ADDENDUM No. 1 – (February 19, 2019)

ADDENDUM TO: Install Security Gate, Main Guard Post, RJS
BID NUMBER: Bid #18-07
BID DUE DATE: Thursday, February 21, 2019 not later than 10:00am

EXISTING GUARD POST PLAN

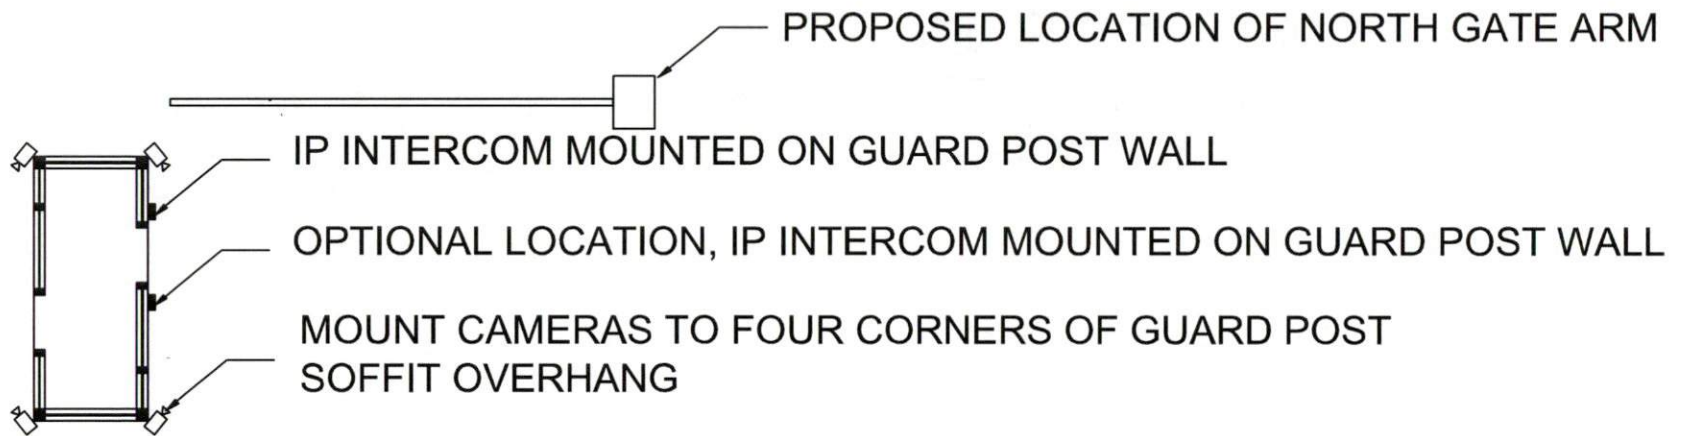
Power and fiber accessible from spare in cooling tower yard

1601-080 Doorking Barrier Gate Operator and 16' 1601-520 Doorking Barrier Gate Arm or approved equal

PROPOSED LOCATION OF INTERCOM

Provide 6 concrete filled 8" diameter removeable bollards per specifications

1601-080 Doorking Barrier Gate Operator and 16' 1601-520 Doorking Barrier Gate Arm or approved equal
